June 20, 2017

Site: Tukwila Village, International Blvd at S. 144<sup>th</sup> Street, Tukwila, WA  
Site visit: June 1, 2017

**Arborist Services: Coast Redwood Damage & Recommendations**

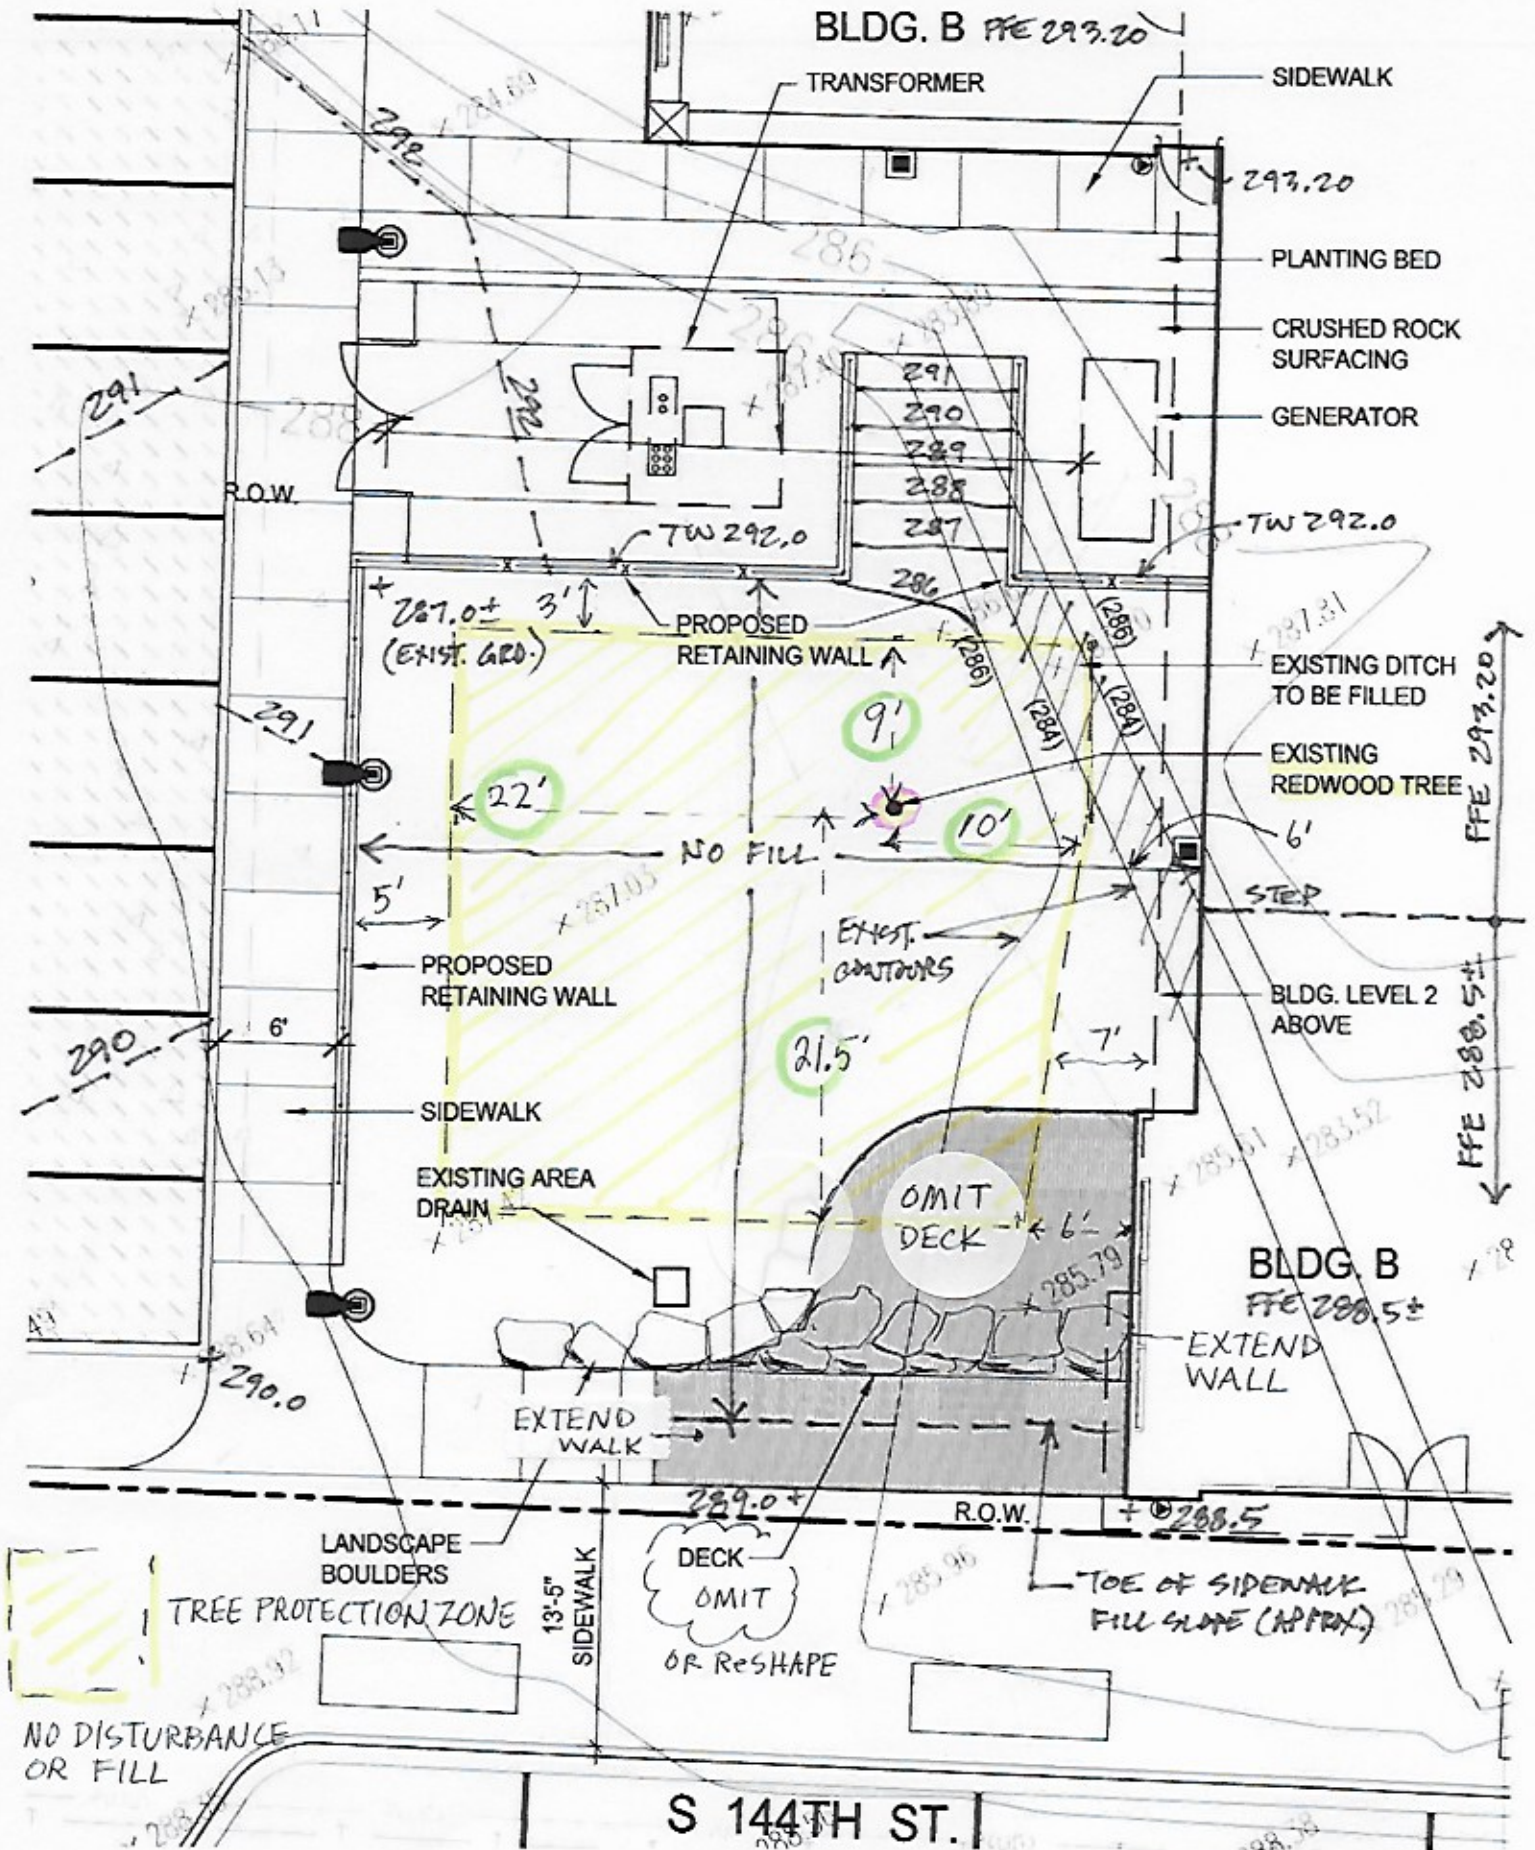
Above: The same tree 6/1/2017. The grade has been raised on all sides. Other trees were removed.

Above: 6/1/2017. The existing drainage swale can be seen to the left, east of the trunk. Note the orange protection fence adjacent to the swale. The portion of the swale to the north has already been filled.
